# JONES & BEACH ENGINEERS INC.

**RE: Response Letter 2  
19 Old Gonic Road, Rochester, NH  
Tax Map 131, Lot 1  
JBE Project No. 21090**

We are in receipt of comments from Theresa Hervey, Town Assessing Department, Ryan O'Connor, Conservation Commission, and Dana Webber, Department of Public Works dated September 27, 2022. Review comments are listed below with our responses in bold.

# PROPOSED SITE PLAN "BAYBERRY COMMONS"

**OFF2**

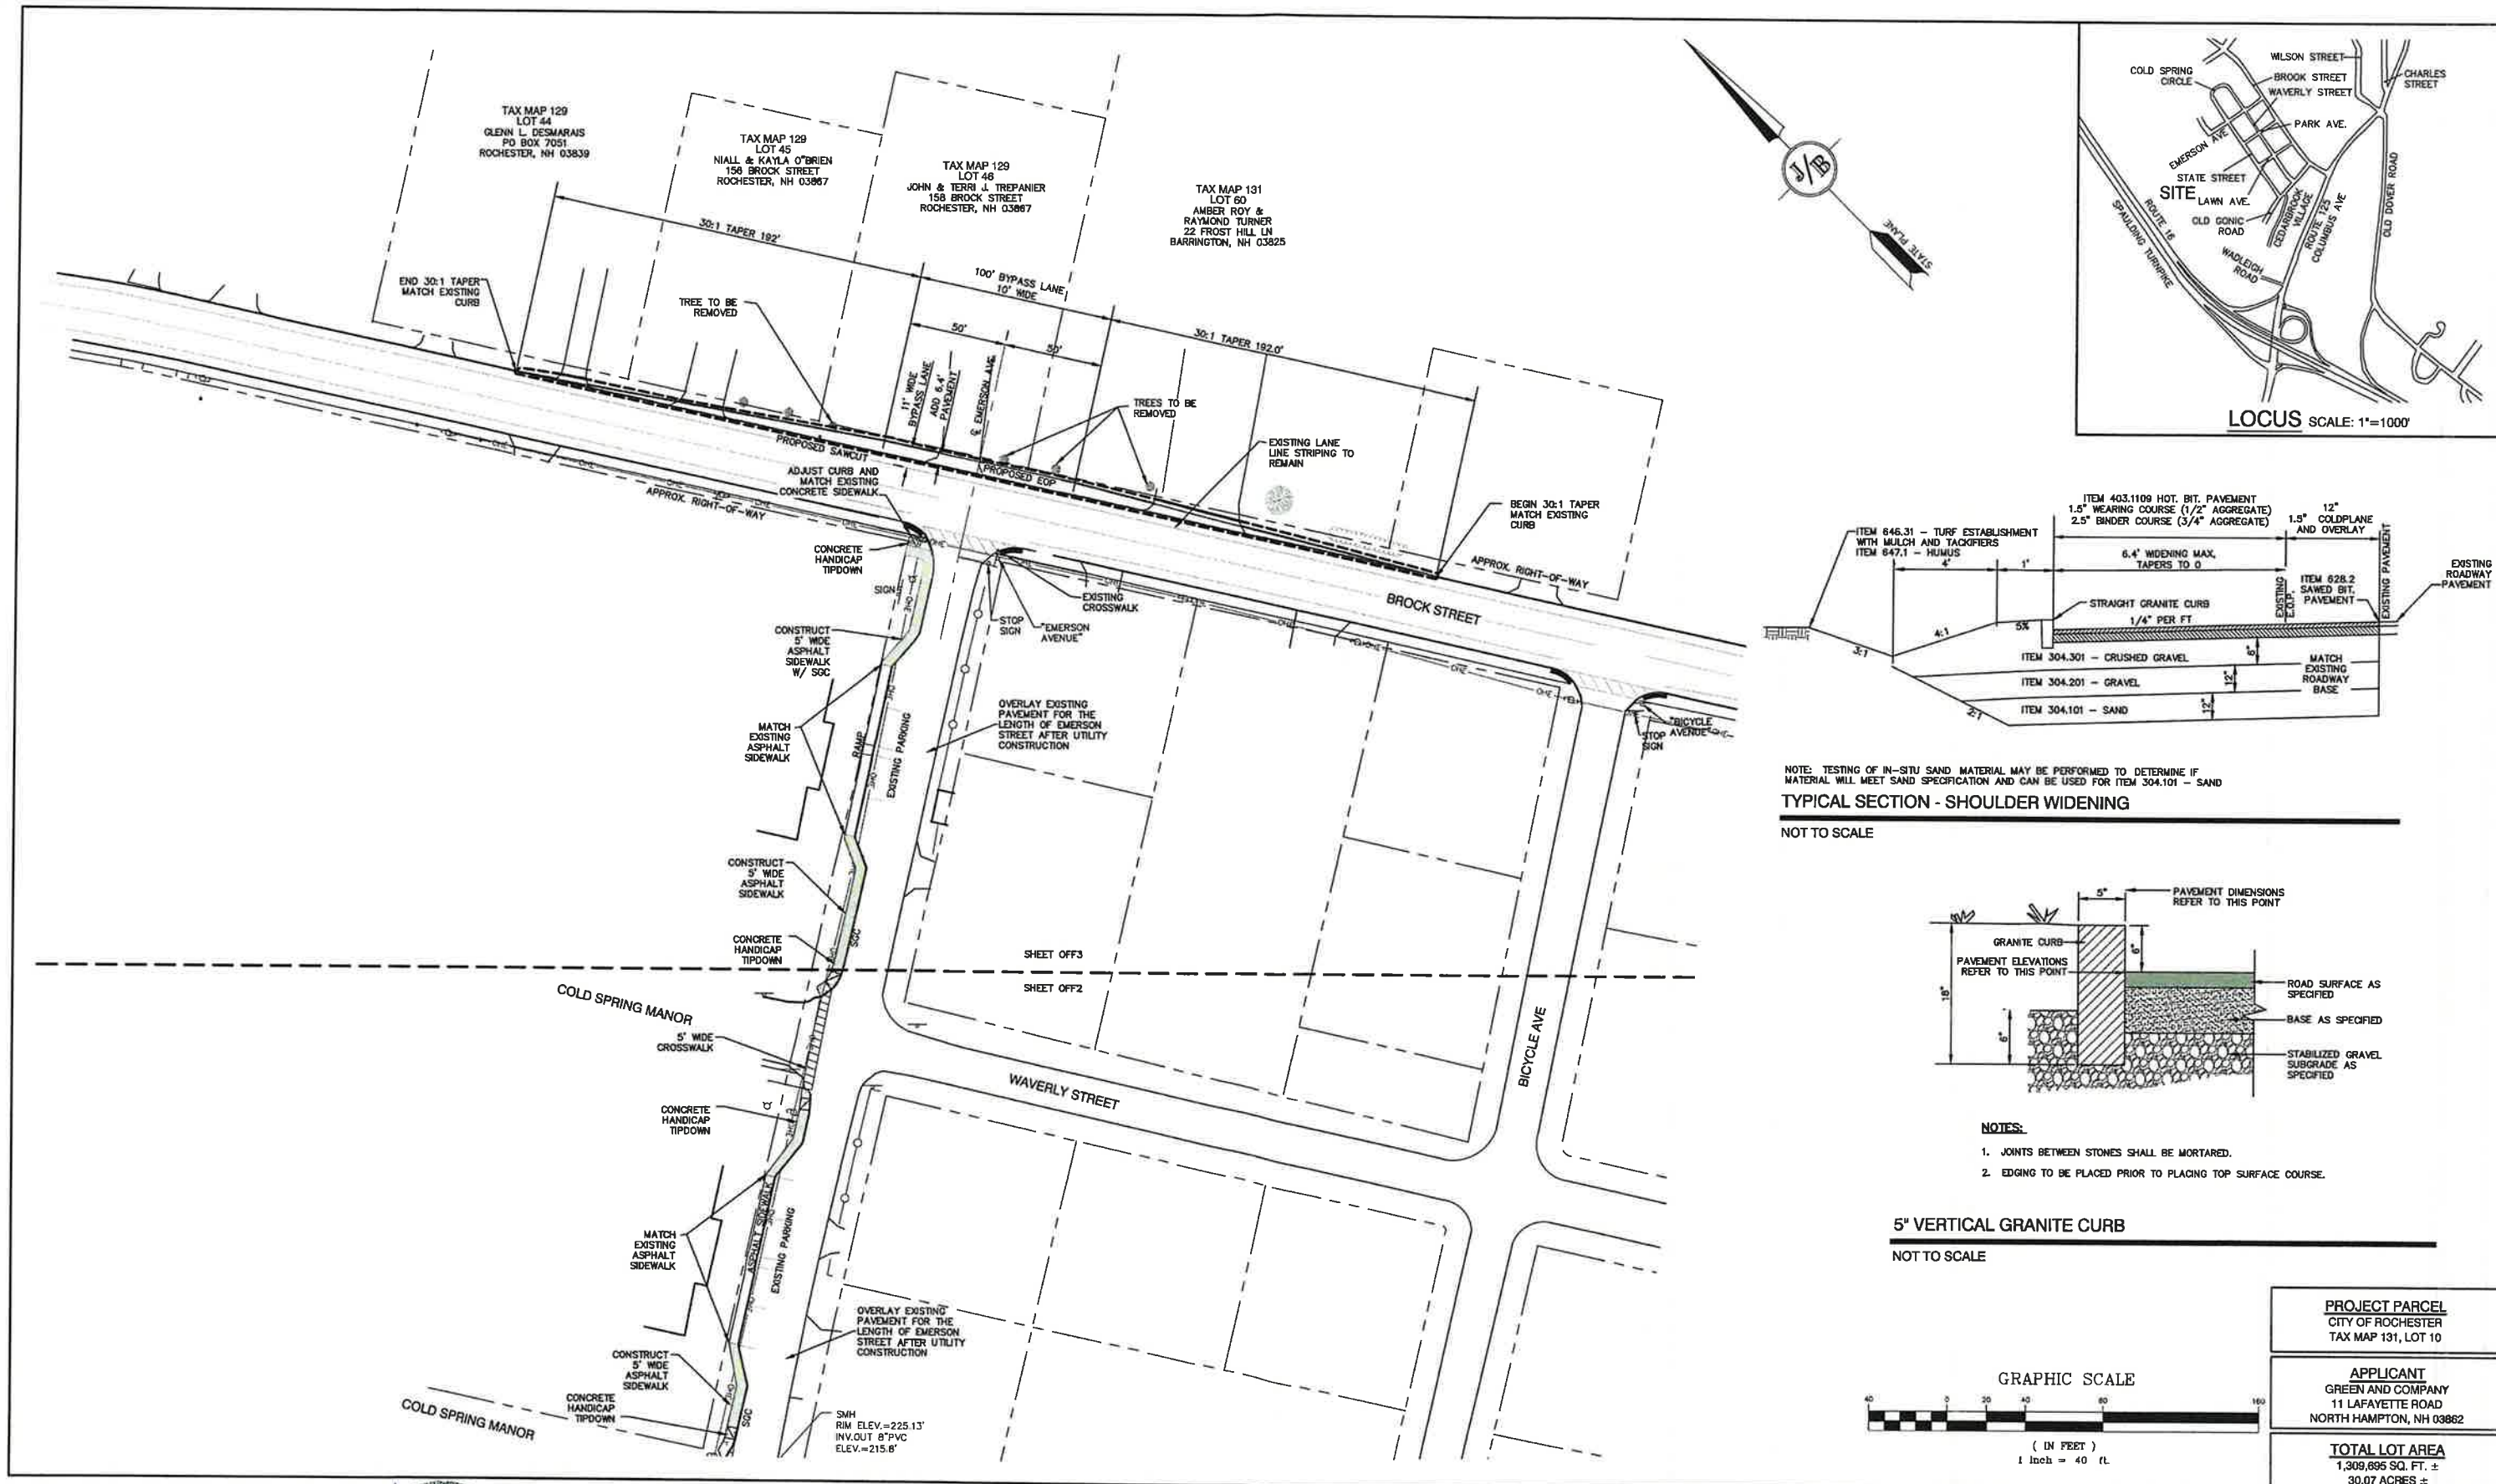
5. *Sheet OFF2 shows overlay of Emerson Street from Emerson Court toward the development. Due to disturbance associated with the water main replacement, curbing, sidewalks and any grading or drainage modifications, the entirety of Emerson Street should be overlaid from Brock Street to Emerson Court.*

**RESPONSE:** The plans has been updated to note that the entirety of Emerson Street will be overlaid due to the disturbance of the water main, curbing, sidewalks, and grading and drainage modifications.

DRAWING No.  
**OFF3**  
SHEET 37 OF 48  
JBE PROJECT NO. 21090

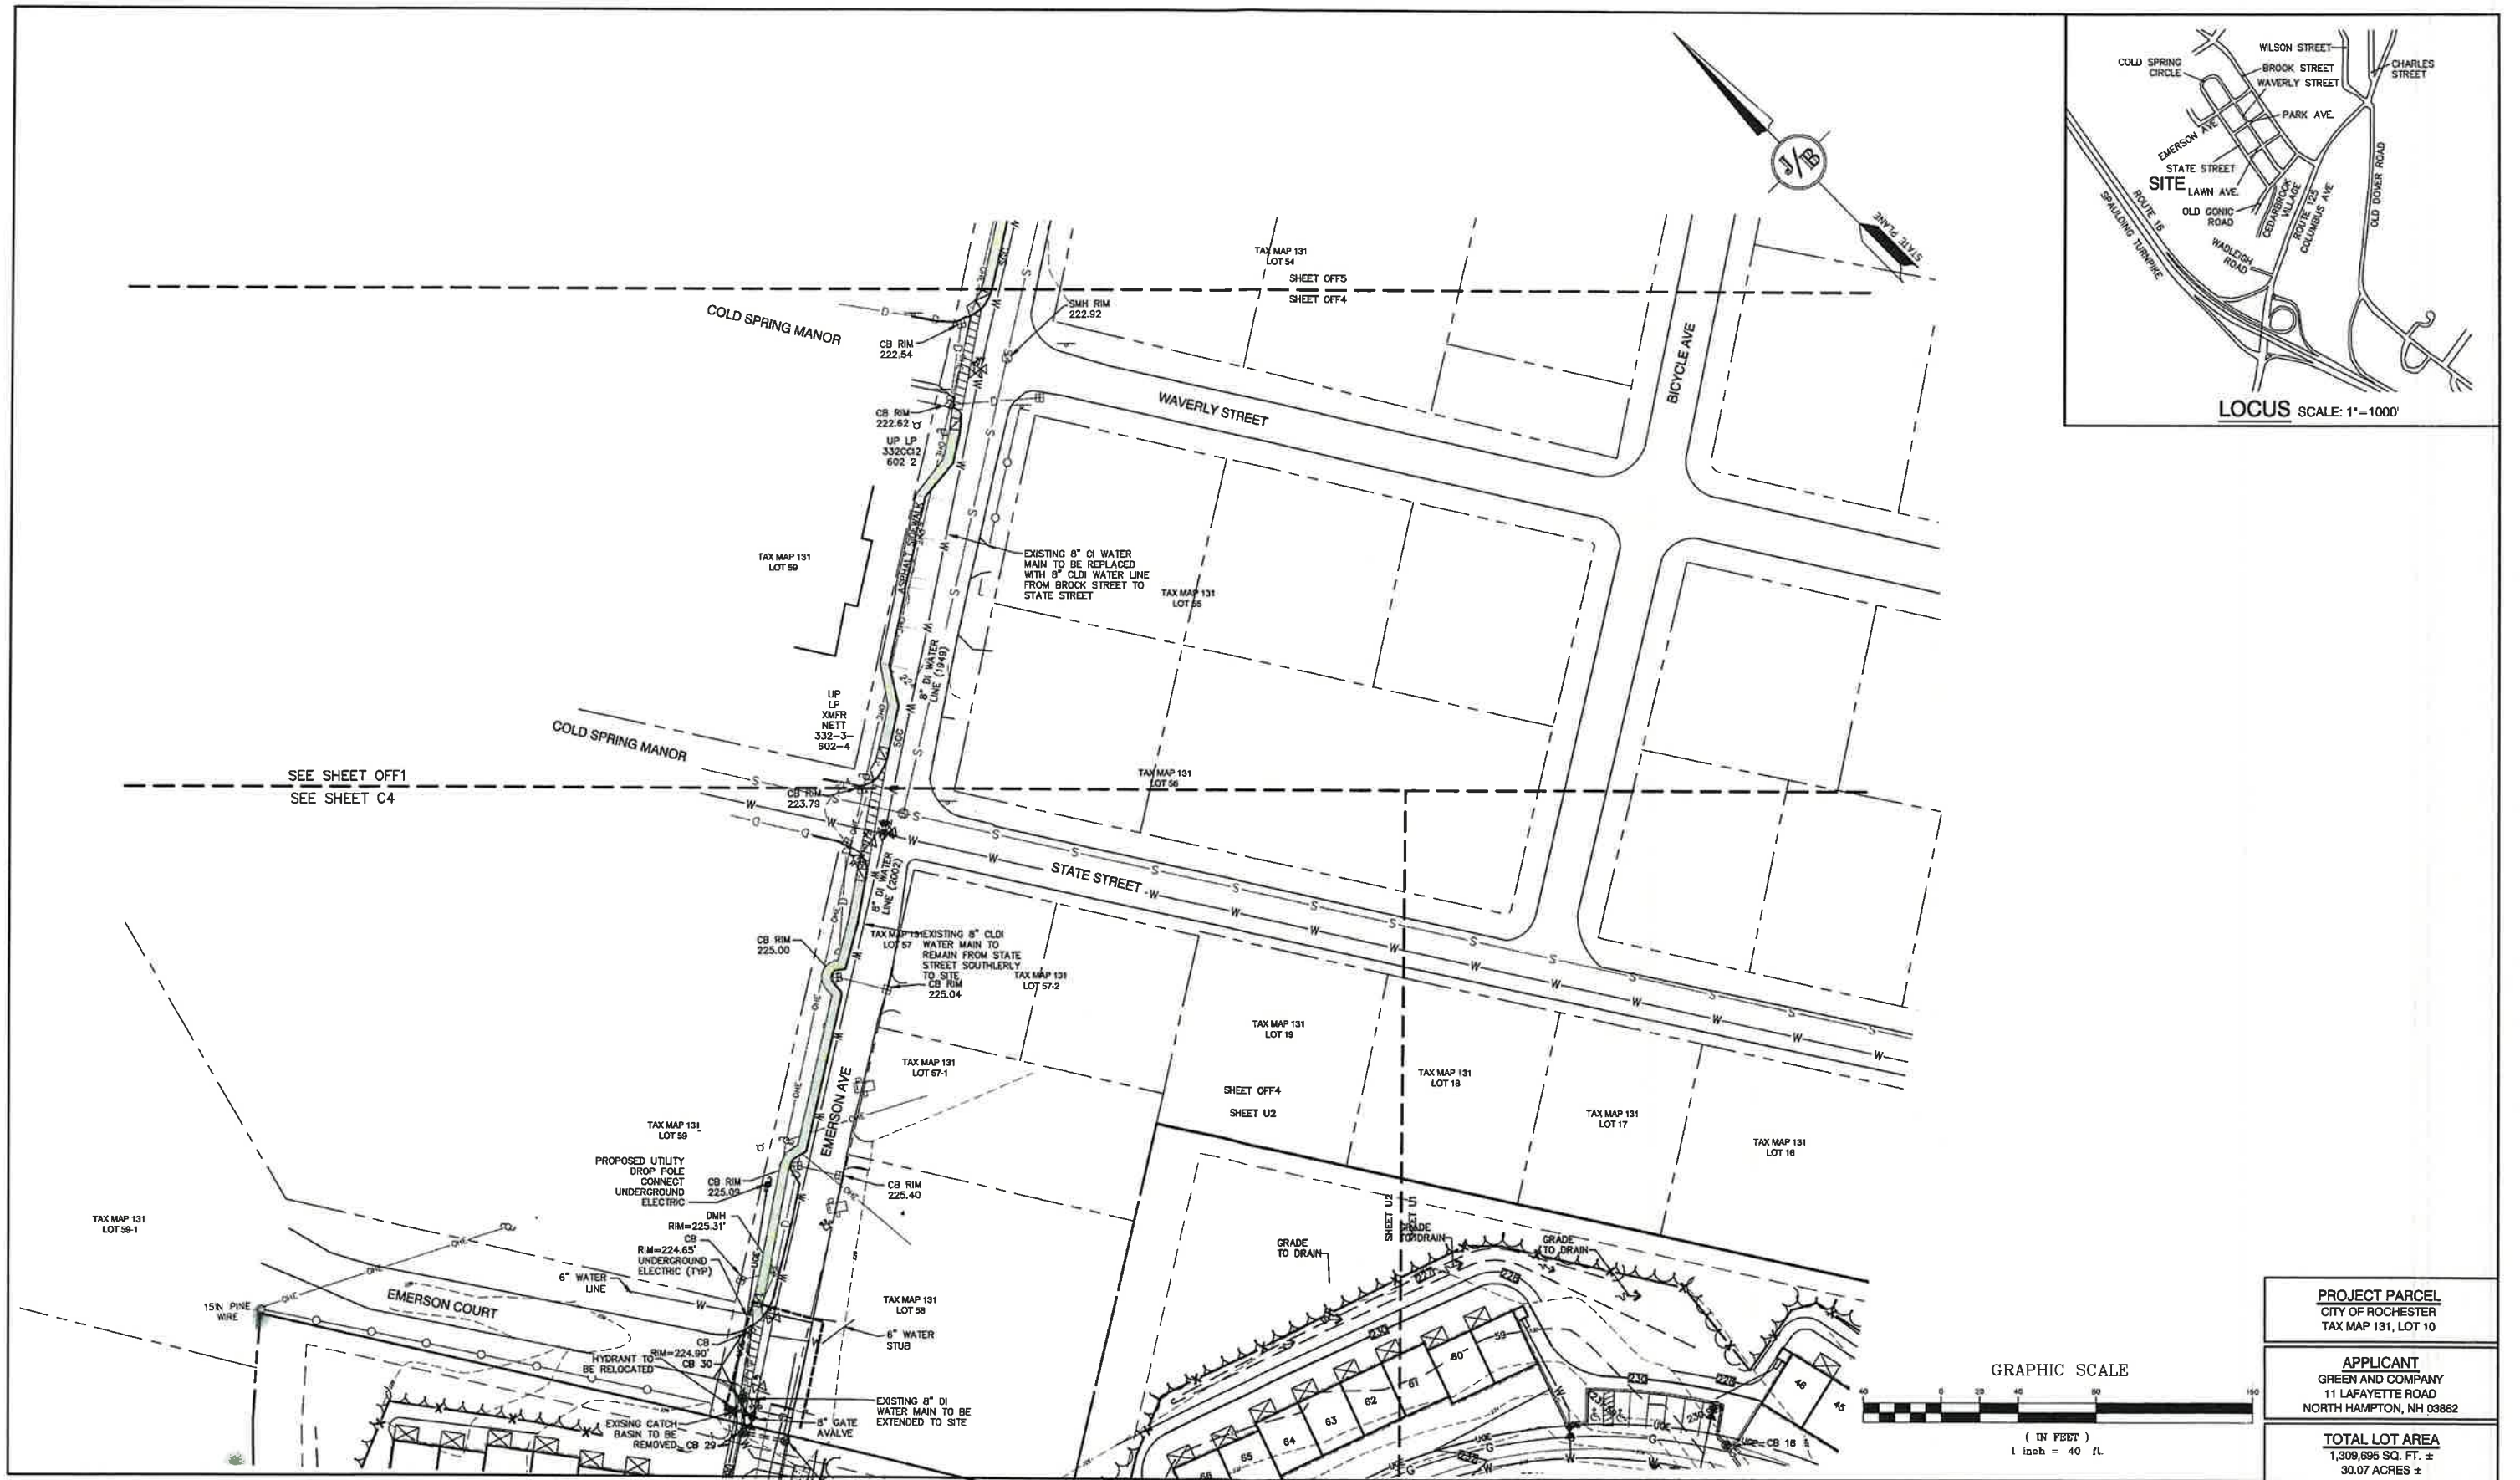
- b. On Sheet OFF3, modify the shoulder widening detail to show 1  $\frac{1}{2}$ " top course  $\frac{1}{2}$  aggregate and 2  $\frac{1}{2}$  inch binder course  $\frac{3}{4}$ " aggregate.

**RESPONSE:** The Shoulder Widening detail on sheet OFF3 has been revised to show the above pavement depths.
